SAN ANTONIO WATER SYSTEM
CRESCENT PARK BOOSTER
STATION PROJECT
SAWS Job No. 12-6006
SAWS Solicitation No. B-12-043-CM

ADDENDUM NO. 4
November 1, 2012

DEVELOPER: SAWS		
CONT.	BUDGET PROJ.	
SUBMITTED		
APPROVED		
MAP NO.	SCALE: N.T.S.	SHEET
SECT. NO.		W1
DR.	CK.	JOB NO. 12-6006

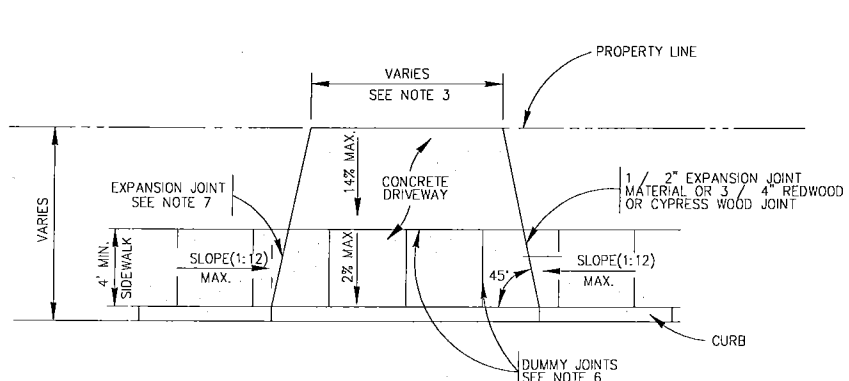
"Note: Install Curb Inlet Gravel Filters at curb inlets near Station 14+80."
4. REPLACE the following attached Sheets in entirety:
 - Sheet W1
 - Sheet C2
